Grandview Reserve Phase 2 Preliminary Drainage Report

March 2024

D.R. Horton

HR Green Development, LLC

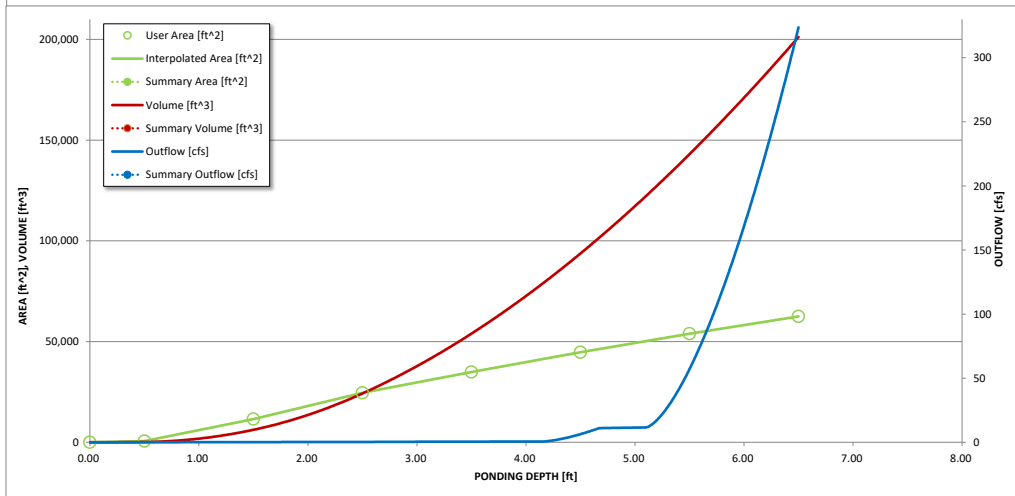
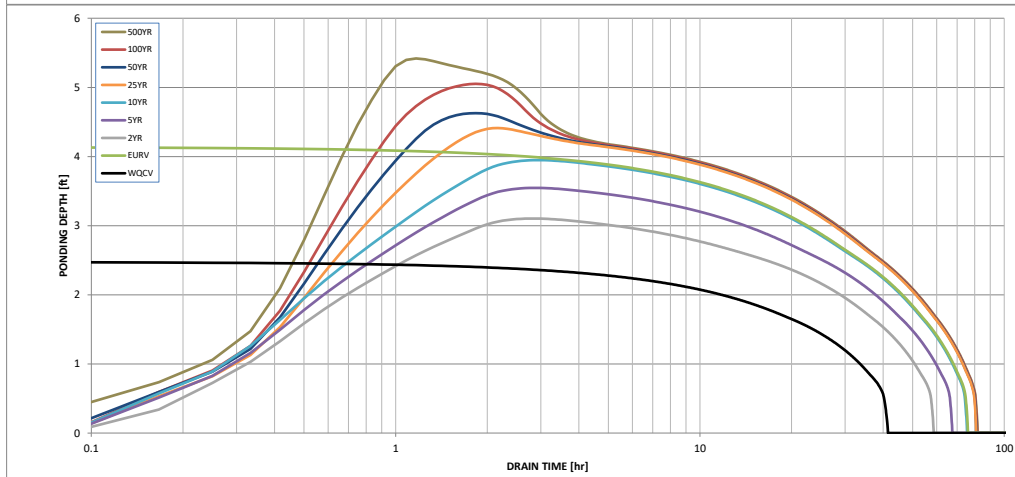
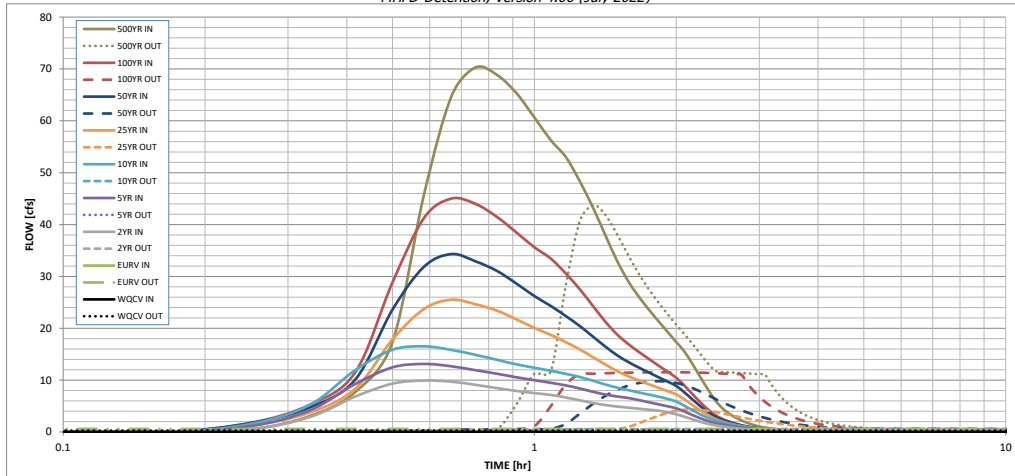
Still not <1 and I'm not sure why it wasn't automatically highlighted as red like it was with V1.

Regardless, your V1 comment responses state that per our conversation you will "not be required to meet pre-development flows for storms between the 5-yr and 100-yr." Which is true. However, the 5-yr ratio for both ponds is still >1. Please address.

HR GREEN RESPONSE:
5 YR SCENARIO HAS BEEN ADDRESSED TO <1.0 RATIO

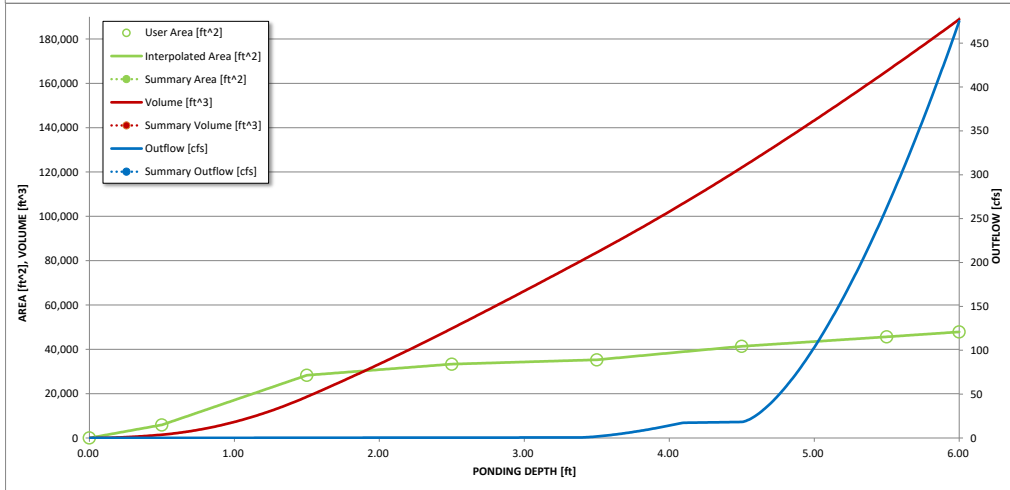
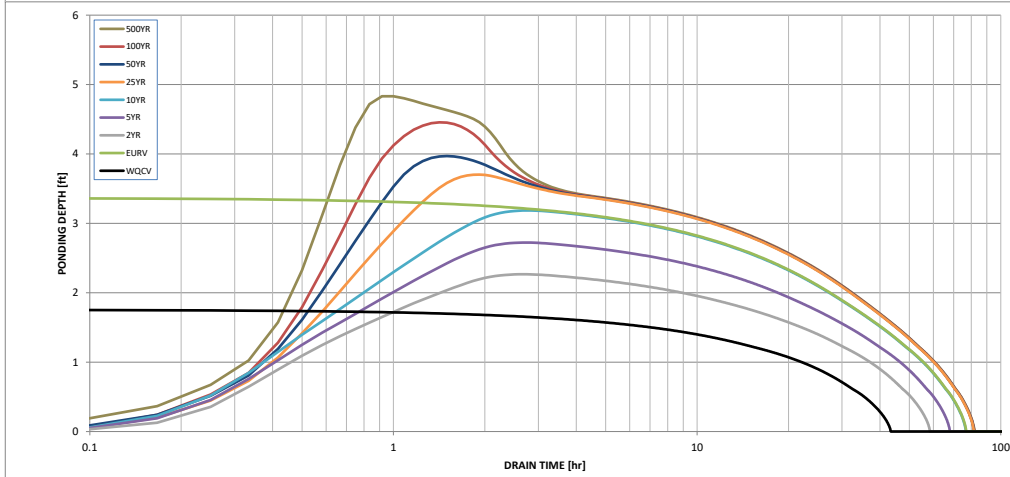
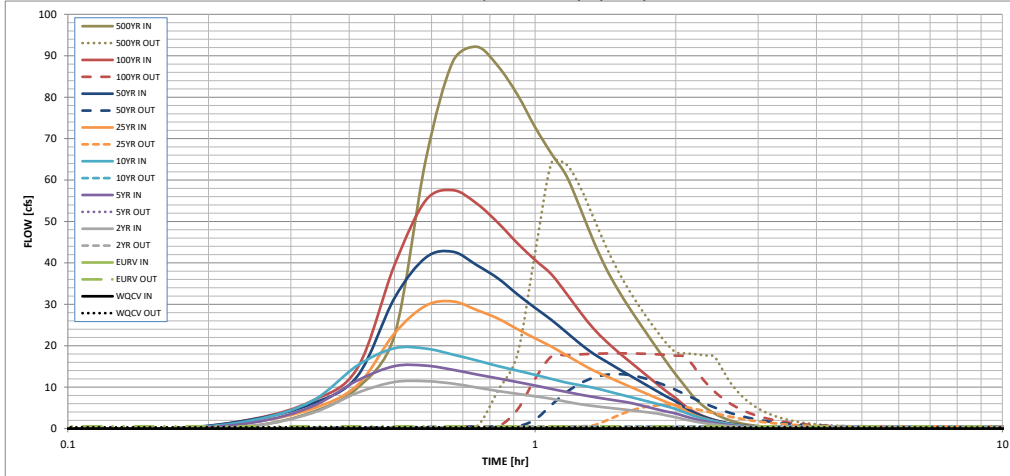
Still not <1 and I'm not sure why it wasn't automatically highlighted as red like it was with V1.

Regardless, your V1 comment responses state that per our conversation you will "not be required to meet pre-development flows for storms between the 5-yr and 100-yr." Which is true. However, the 5-yr ratio for both ponds is still >1. Please address.

HR GREEN RESPONSE:
5 YR SCENARIO HAS BEEN ADDRESSED TO
<1.0 RATIO

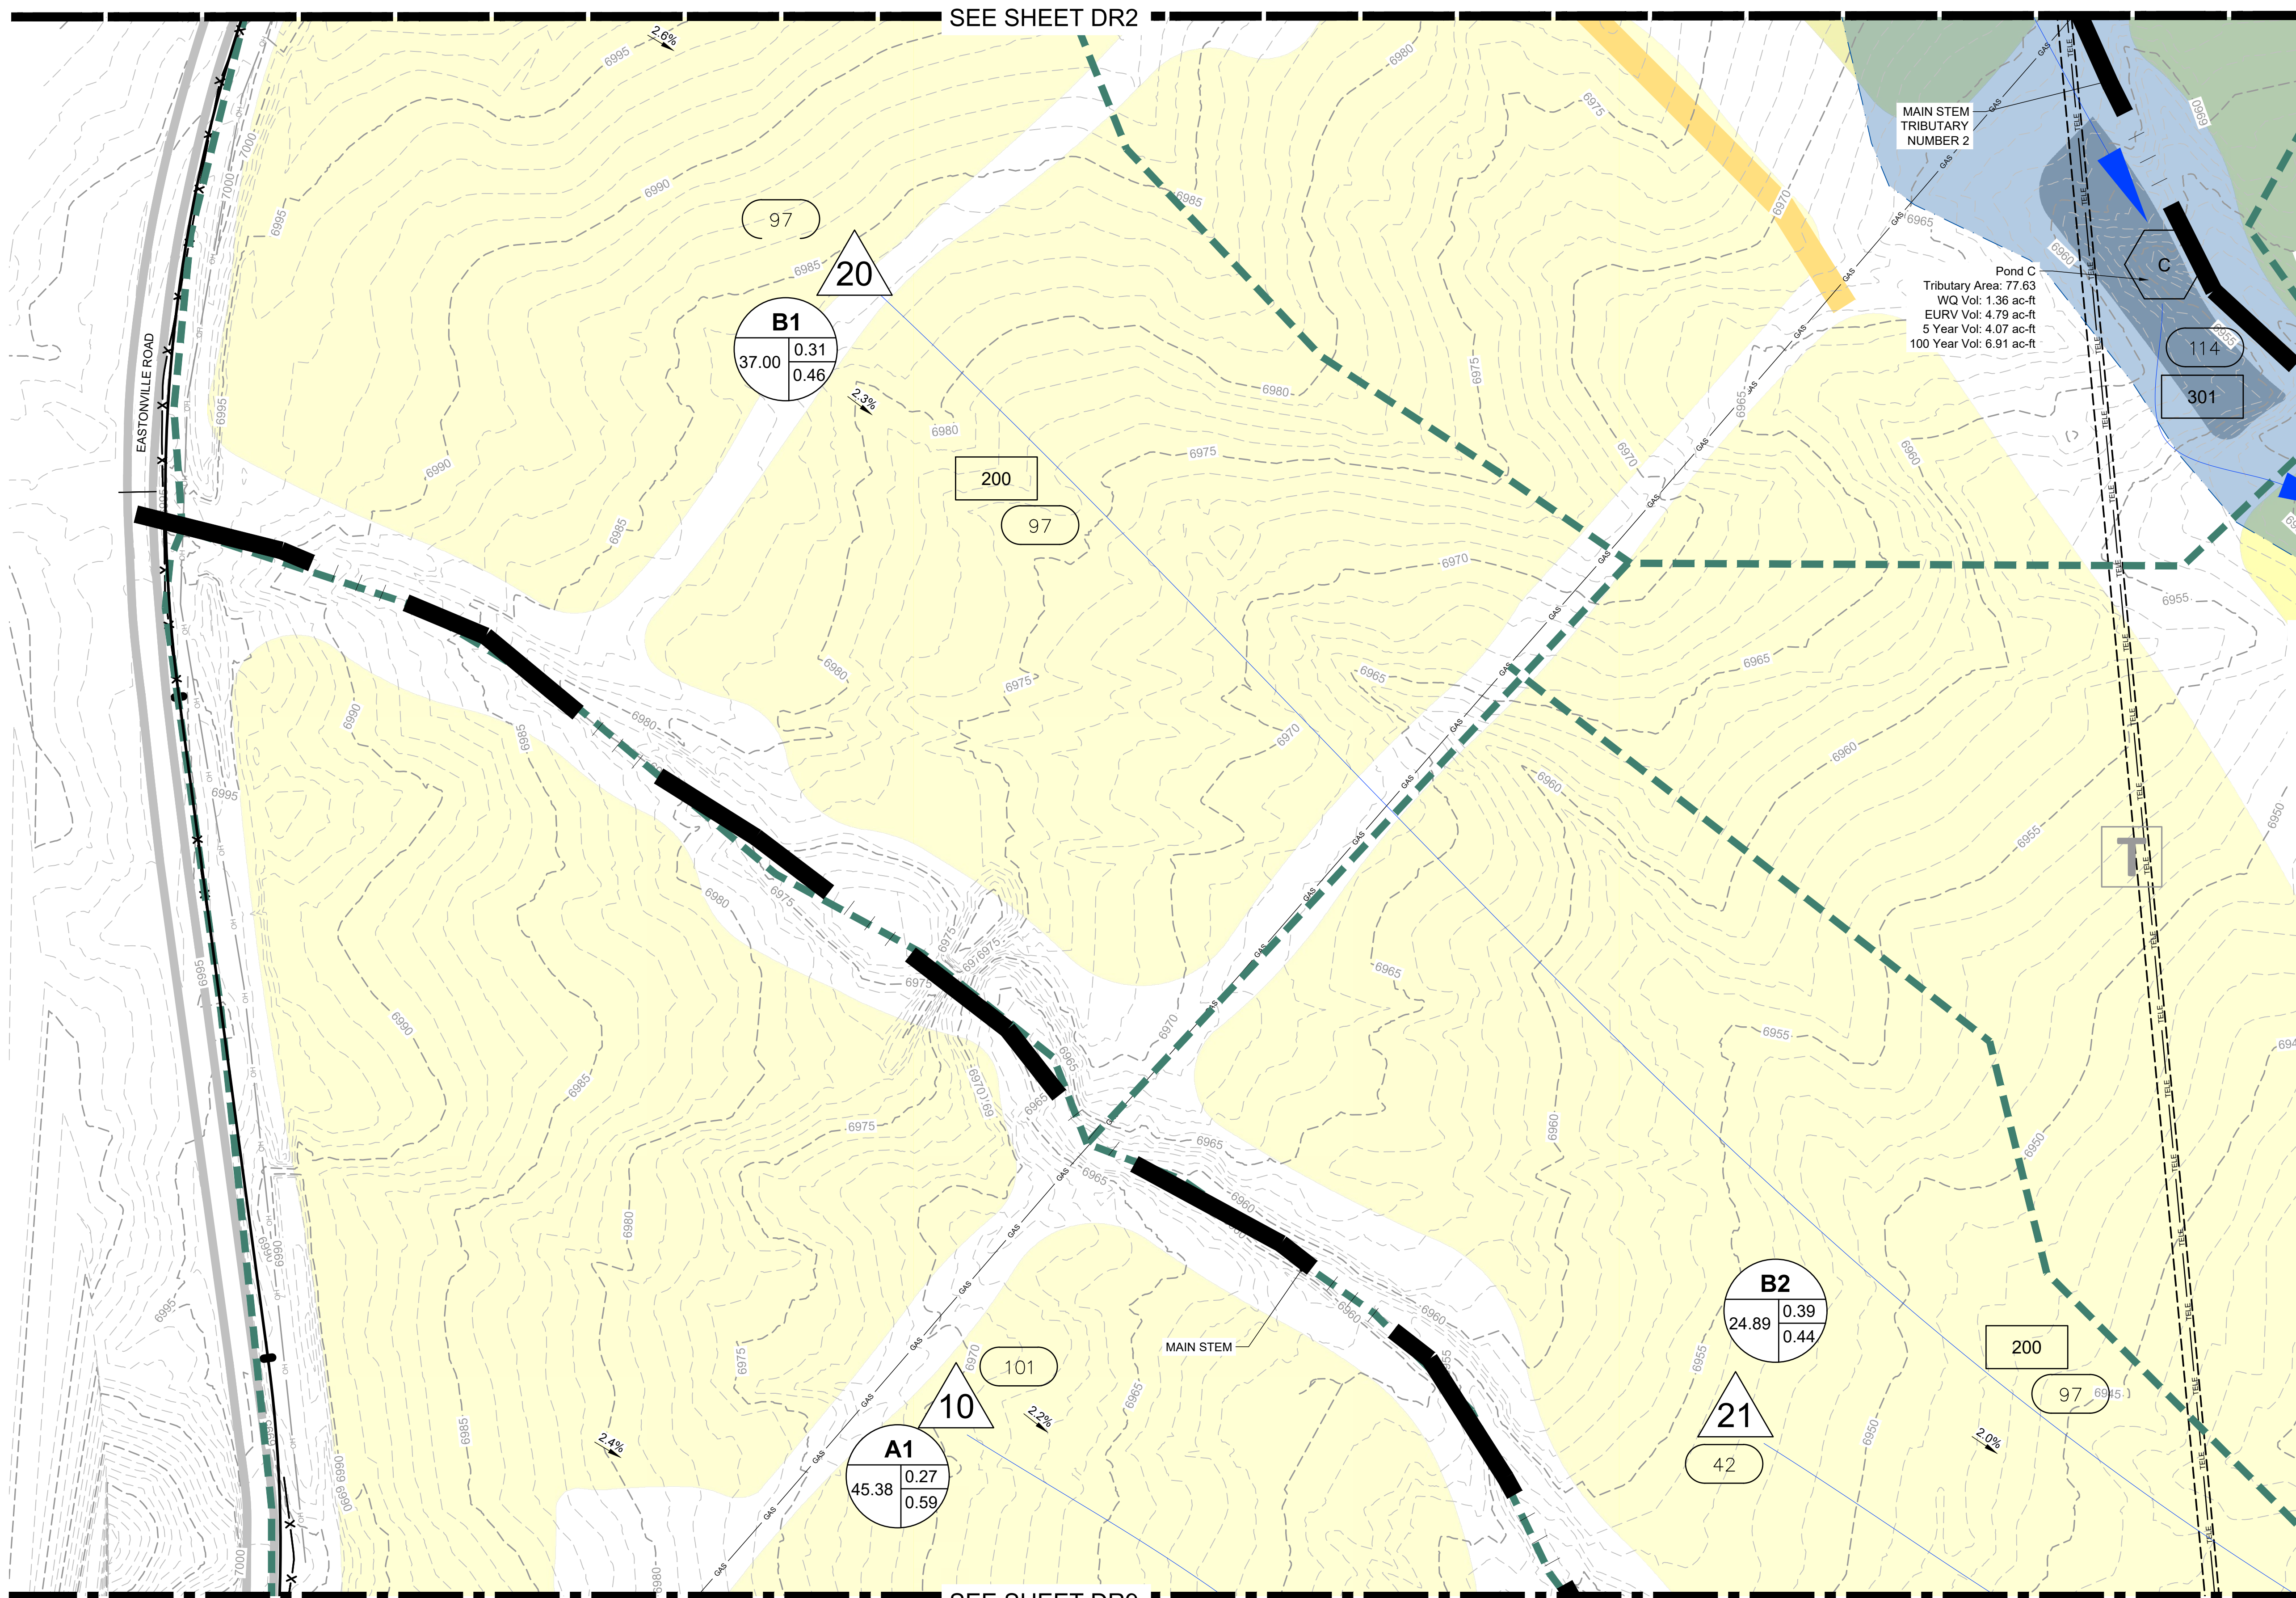
Unresolved comment from Review #1:
Is this Land Use legend supposed to be in color for the colors (like yellow and orange) shown on this map? Either way, please provide a Legend for all of the shaded colors show on these maps.

HR GREEN RESPONSE:
LAND USE LEGEND UPDATED TO BE IN COLOR

SHEET DRN 1

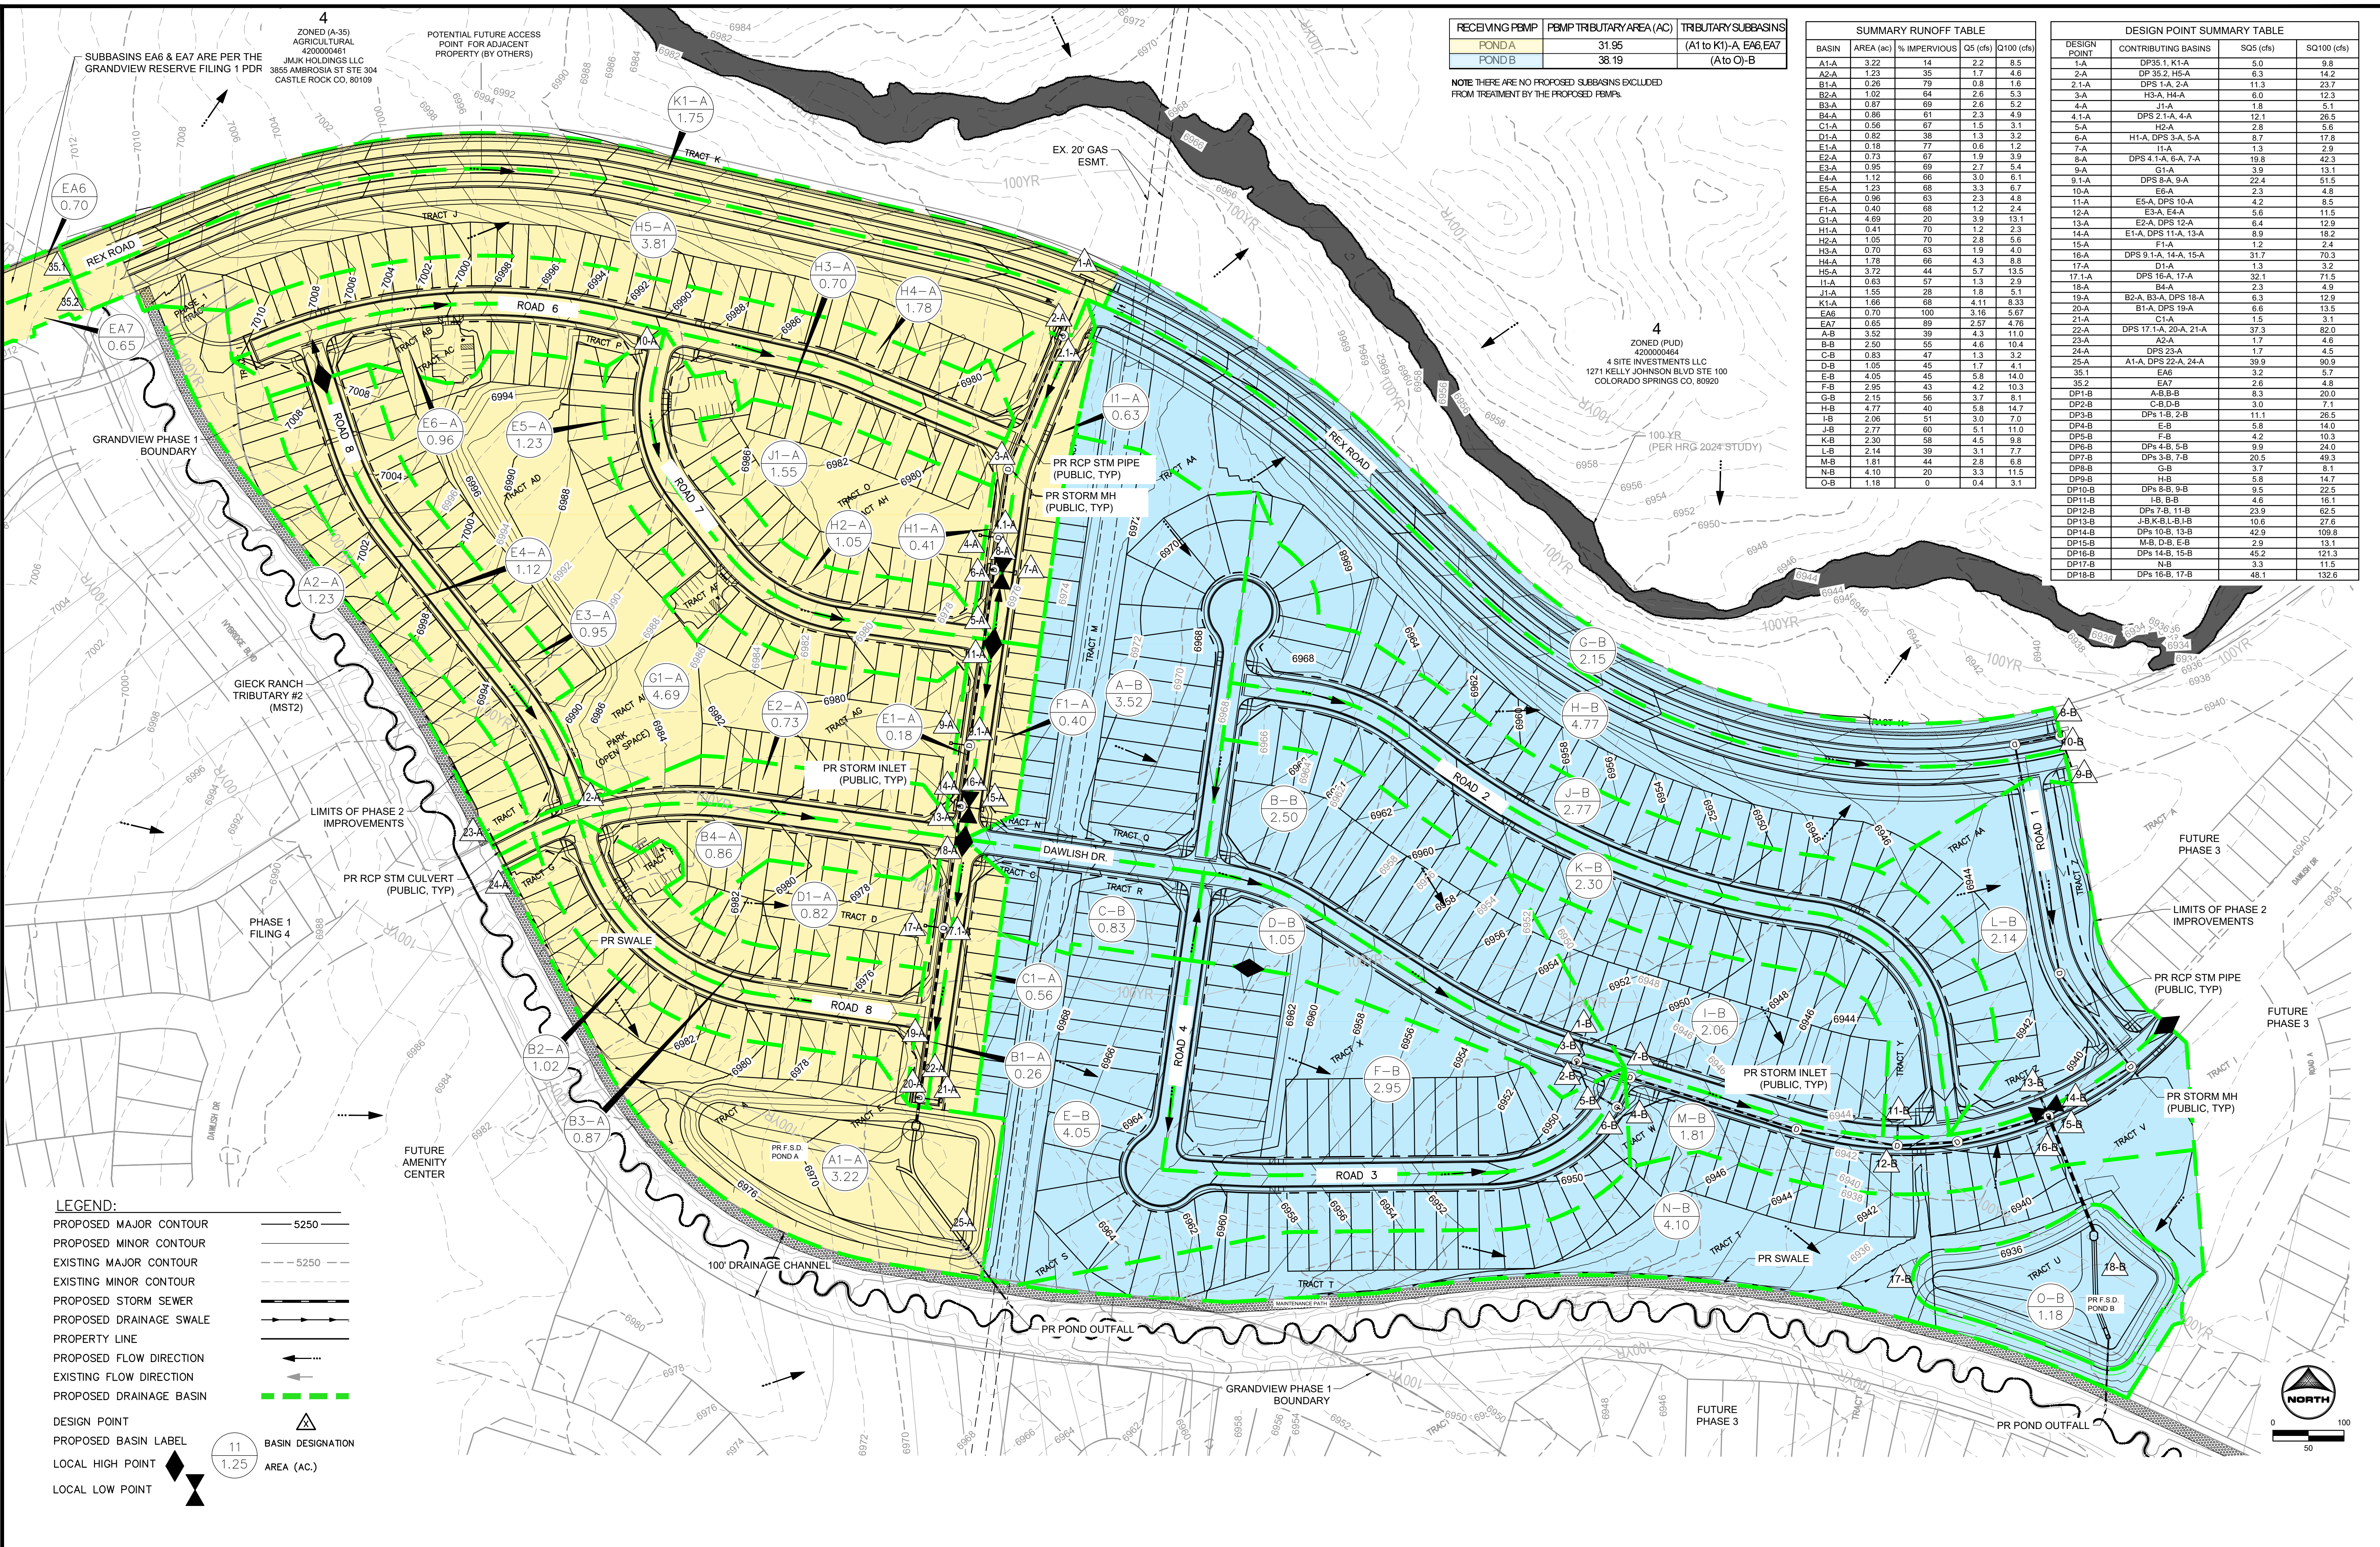
Provide an existing drainage map, specifically for Phase 2. Include design points that will correspond to pond release locations, so historic flows can be compared to pond release rates.

HR GREEN RESPONSE:
PREDEVELOPMENT & POST DEVELOPMENT RELEASE RATES HAVE BEEN DETERMINED BY CUHP. ULTIMATE RELEASE RATE ALSO COMPARED TO IN REPORT PER THIS EXISTING MAP. THEREFORE, SEPARATE MAP WOULD NOT BE BENEFICIAL TO ANALYSIS & WOULD ONLY CREATE MORE CONFUSION.
